TO: Jim Wheeler, Planning Manager

SUBJECT: Additional Information in Support of Exhibit A to the City Attorney's October

Re: Review of AKS Locally Significant Wetland Report – Veranda Subdivision

MPLAN 21-00652

Figure 6c. Wetland Delineation Map - Western Section

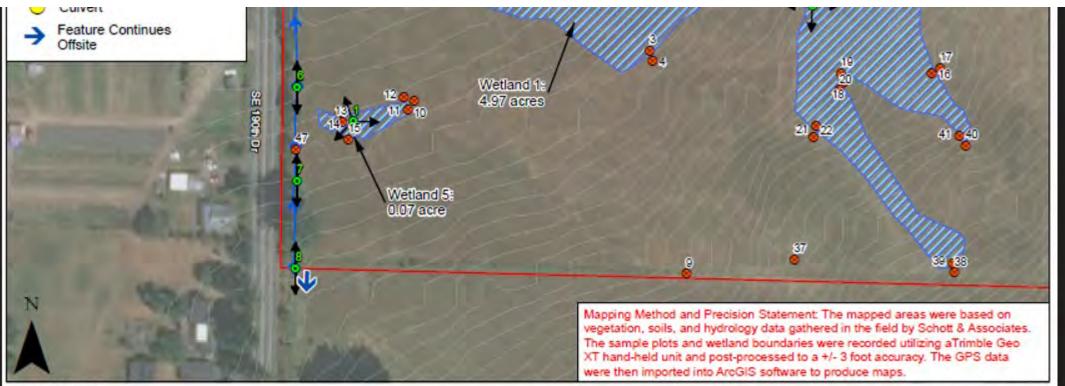
Where does culvert discharge to? Surface water connection to Kelley Creek?

Figure 6. Simulated flow through the Riverine Valley landscapes.

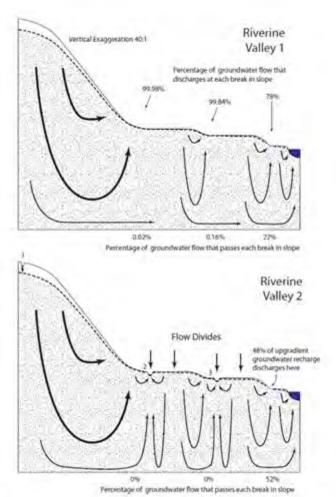
There is a lot of information to go through and I obviously have not spent time on the site to understand site context, etc, but I think that the figure below provided by Melanie is key within the context of classifying Wetland 1 as locally significant or not. What gives me some pause is the fact that they suggested that the wetland did not have surface water in April of 2018 and March of 2019 when surveys were done though the criteria suggests that classifying it as locally significant only requires that surface water be present during the growing season.

As Melanie stated, I think they need to provide some analysis, using well logs or geotechnical boring information (spatially) that better defines the connection between the wetland and the local shallow groundwater elevation. In one sentence they state that the wetland is only there because of broken or damaged drain tiles but then suggest there is no groundwater connection. That doesn't make sense because if the drain tile were installed to address a high shallow groundwater table that results in the formation of seasonal surface wetlands than that implies that these wetland are maintained by groundwater rather than direct precipitation. If they don't think there is a groundwater connection than they need to show that the wetland functions like the first cartoon, and not the 2nd and 3rd cartoon.
